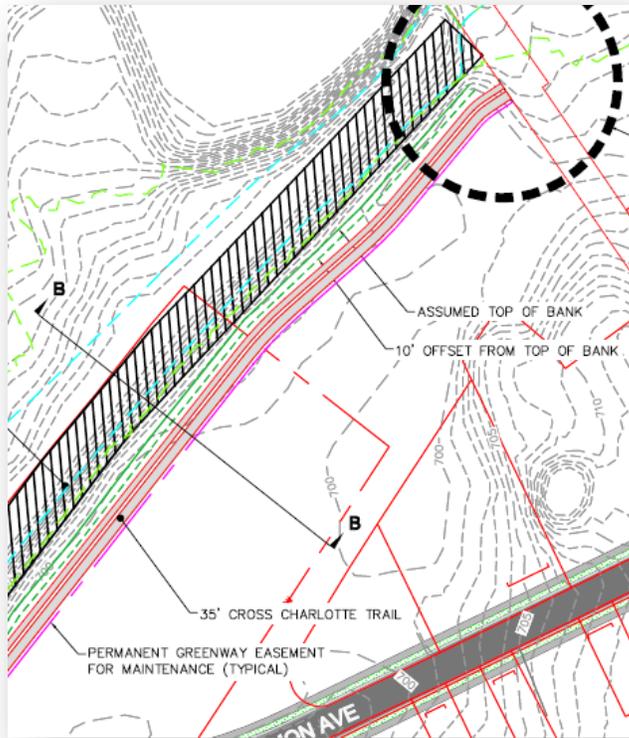
3. CDOT recommends that the petitioner construct the Cross Charlotte Trail per the cross section and along the alignment shown below, including a permanent 35' easement be dedicated for future maintenance of this trail.

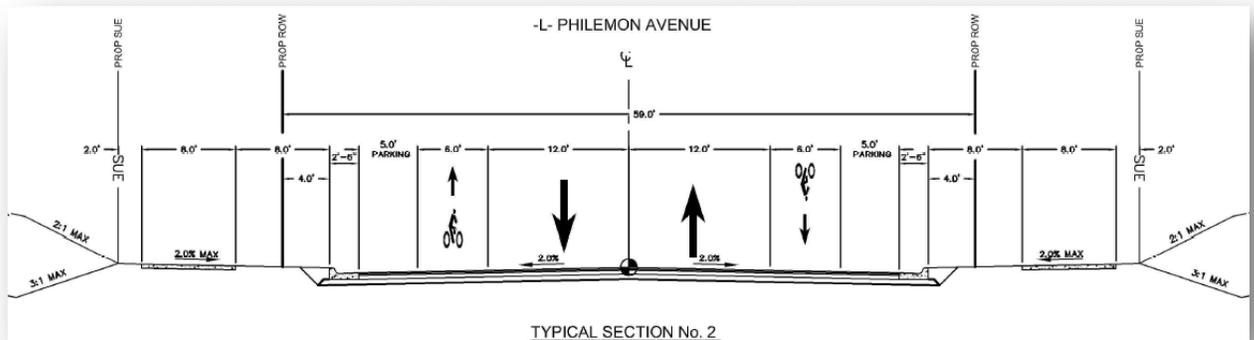
1. CDOT request that the petitioner revise the proposed typical section shown on sheet RZ-2 to include on-street parallel parking and bike lane. This matches the proposed cross section for the future CIP project that could extend Philemon Ave below.
